**RE: Aurora Regional Navigation Center – Comment Response Letter**

HDR, on behalf of the Aurora Regional Navigation Center project team offers these responses to your comment letter dated September 26, 2024, regarding the Pre-Application Meeting held on September 12, 2024.

The City's comments are listed below in **bold** followed by our response in *italics* for items mentioned in pages 6 – 24 of the 32-page document, which focus on the Step 1 - Planning Phase submittal.

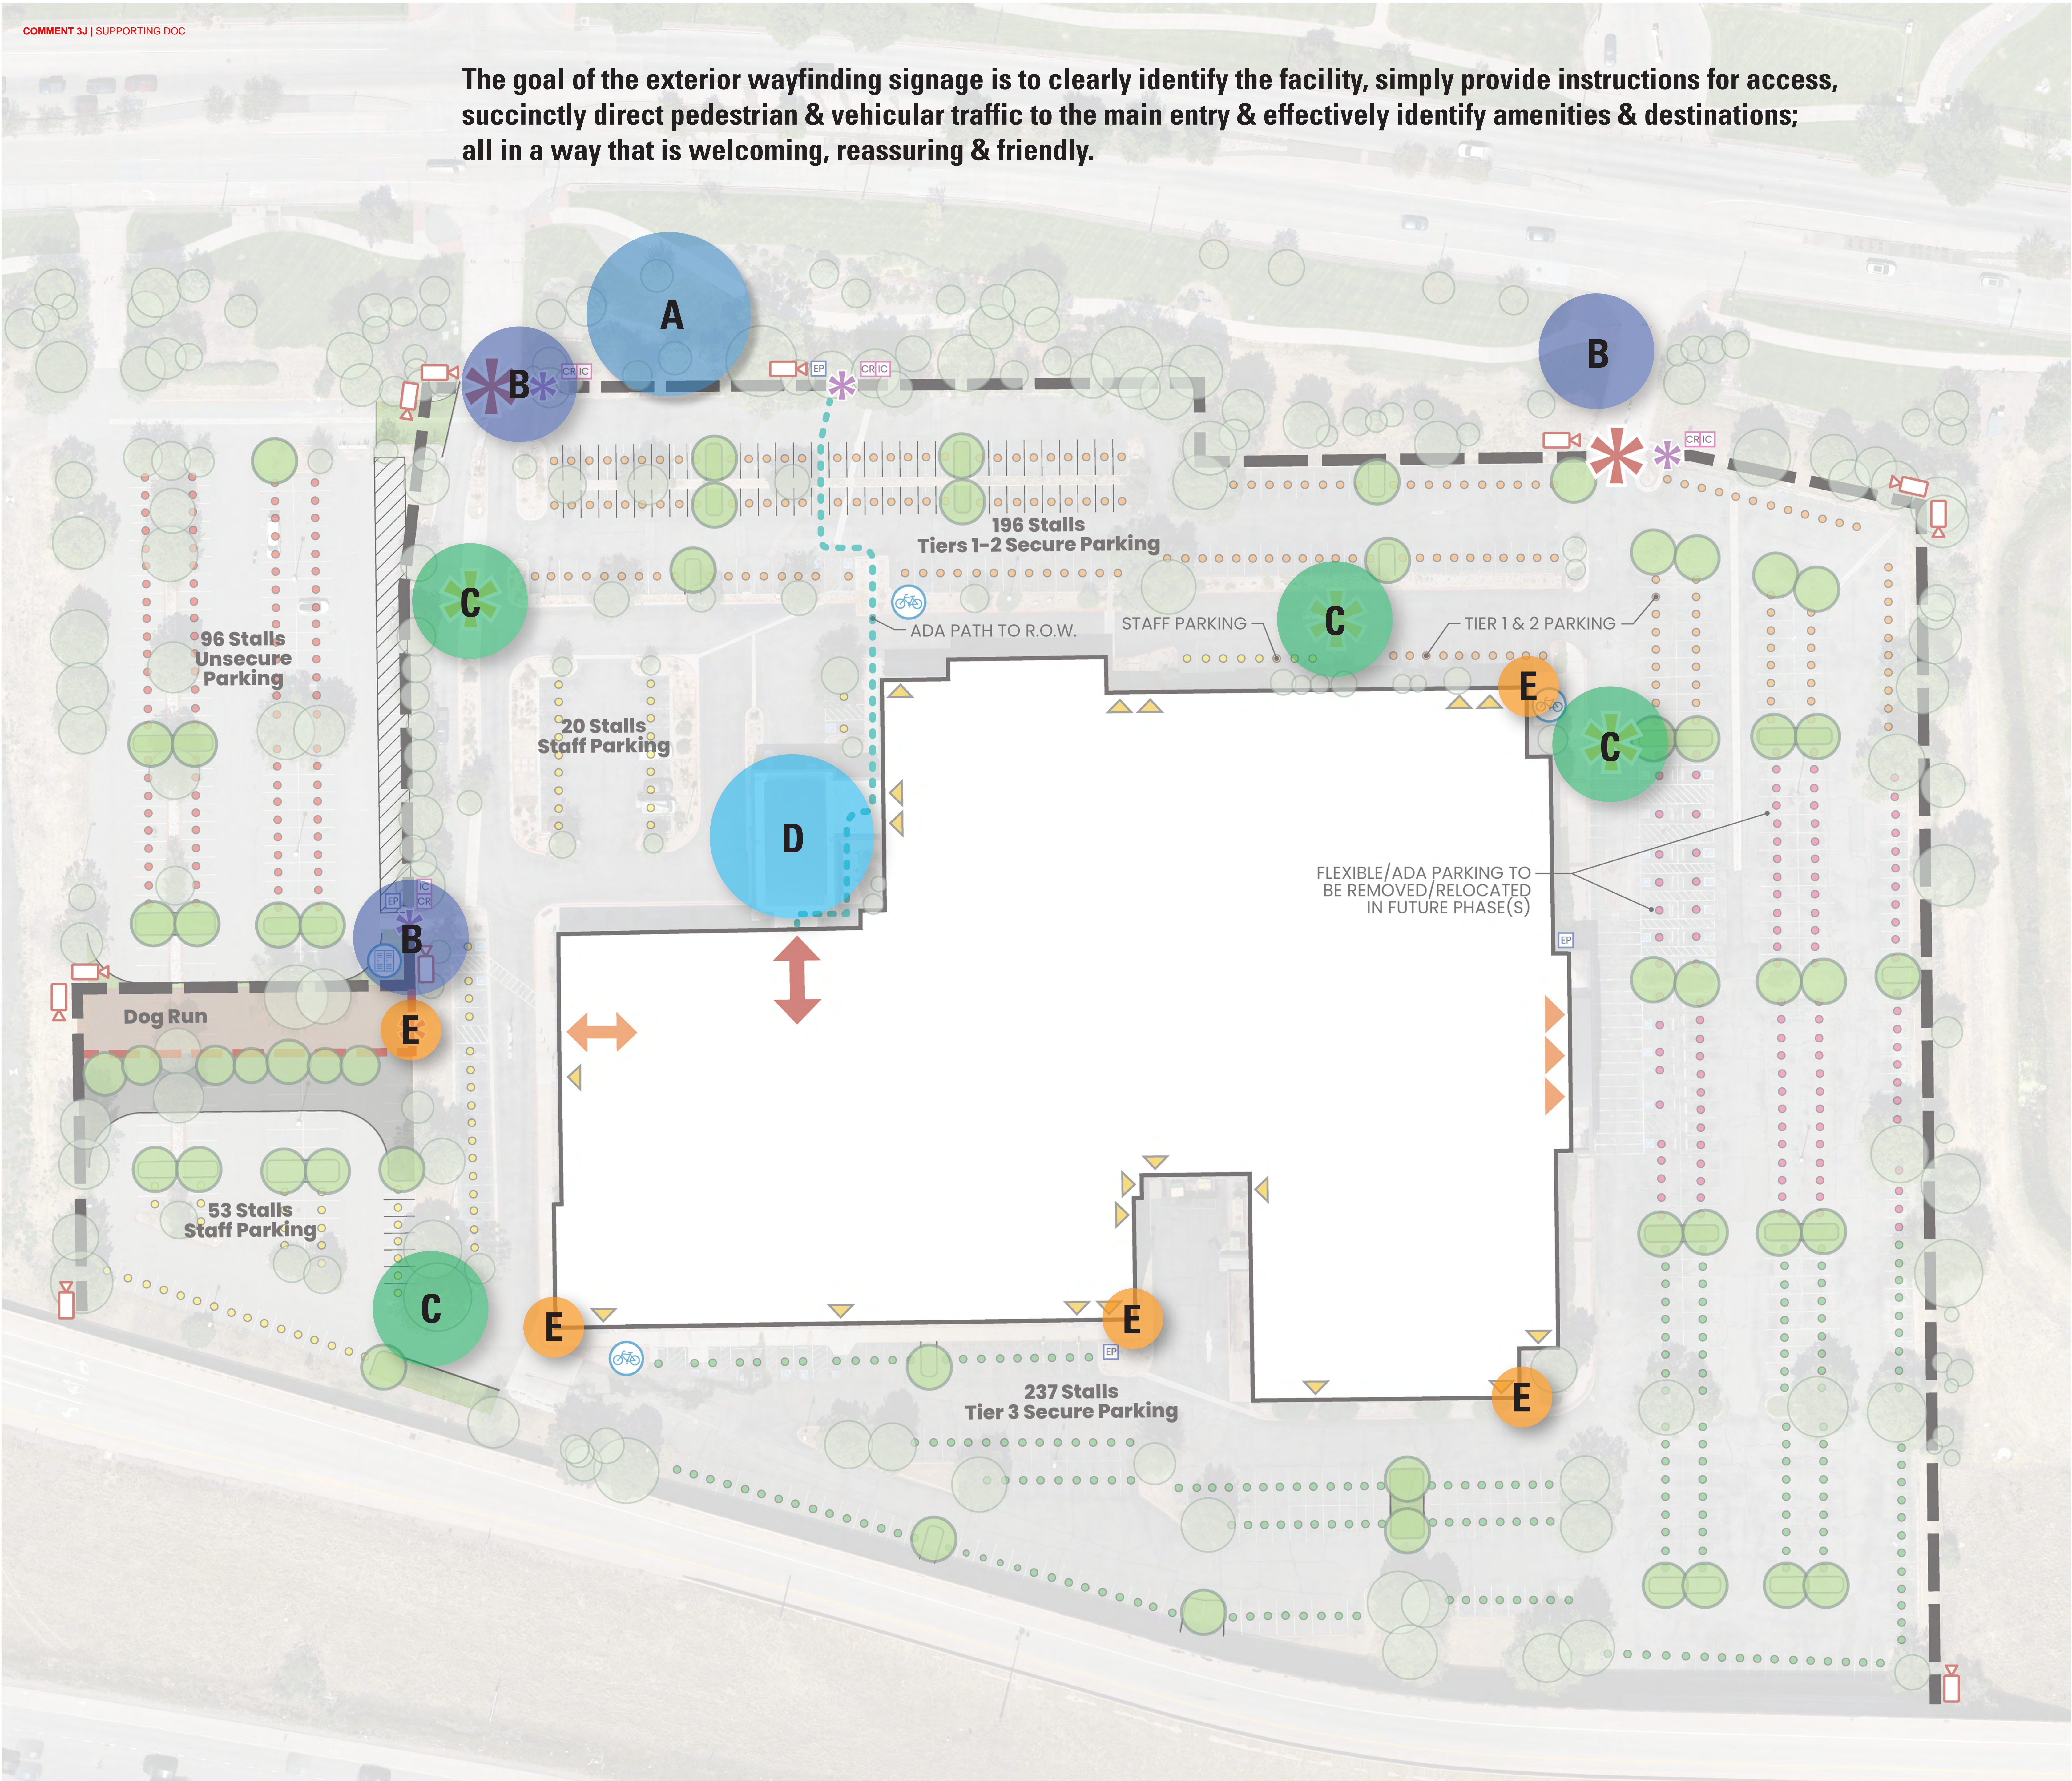
**Please note that there are many parking spaces throughout the site that appear to be only 13-15' in length. These were not shown on the original Site Plan and were likely added without city approval. The length of these parking spaces poses an issue, particularly if adjacent to any fire lane easements. Staff highly recommends that these be re-striped to meet the standard 9' x 19' length required in the UDO. The proposed dimensions for all parking spaces should be identified on the Site Plan.**

*The proposed ARNC facility has a maximum design capacity of 1,238 occupants. For a Public Use Facility, the required vehicular parking is 1 space per 4 persons design capacity. This totals 310 vehicular parking spaces, of which 8 should be accessible, and 16 bicycle parking spaces. The full occupant breakdown is included in the appendix. The parking spaces are shown on the landscape plans.*

*Response: Acknowledged – Dimensions for the existing parking stalls have been added to the plans. An adjustment has been requested for existing parking stall depths, as lengthening of stalls would interfere with drive aisles and in several instances interfere with fire lane corridors. The vast majority of existing stalls on site meet the 9' width requirement, and measure approximately 16-18' depth.*

## WAYFINDING LEGEND

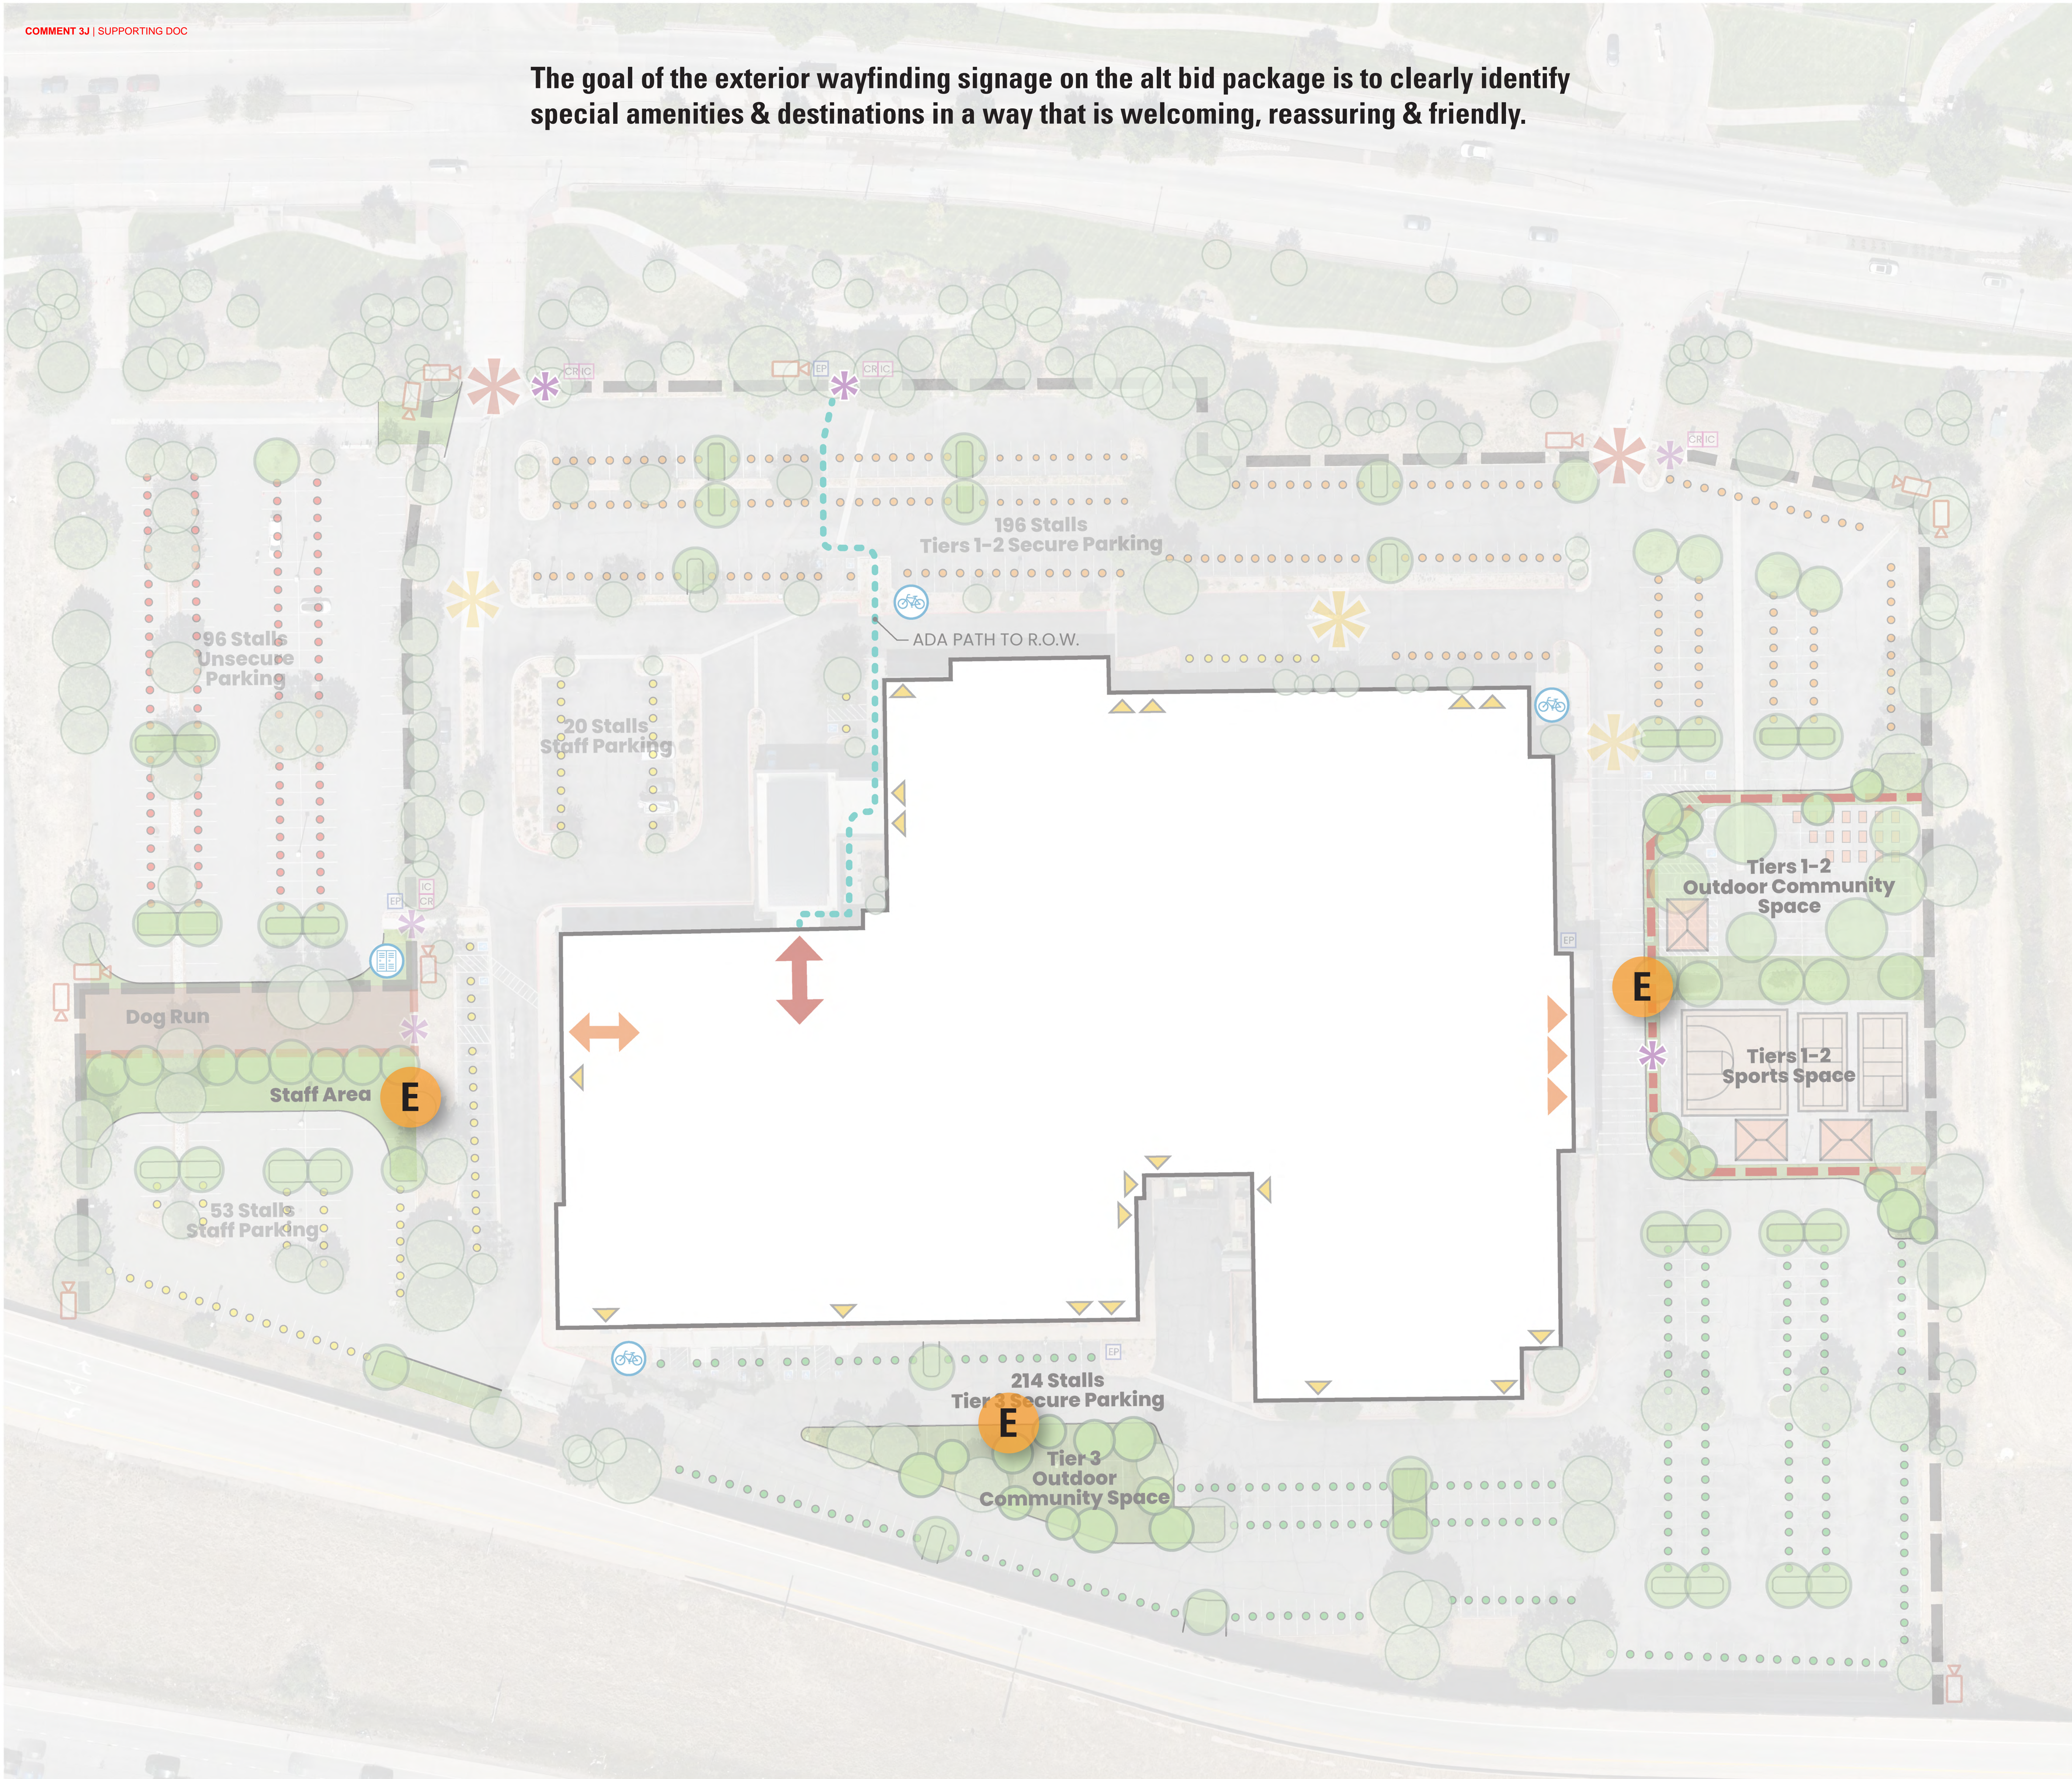
**Section 146-4.10 governs signage standards. Please review this section for complete details. Show the location of any monument signs on the Site Plan and indicate the location of wall-mounted signs on the building elevations.**

*Response: Acknowledged - there is one existing monument sign to remain, shown on civil and landscape plans. There is one new wall mounted sign proposed at the existing building entry canopy. The wayfinding design drawings have been included in the appendix for reference.*
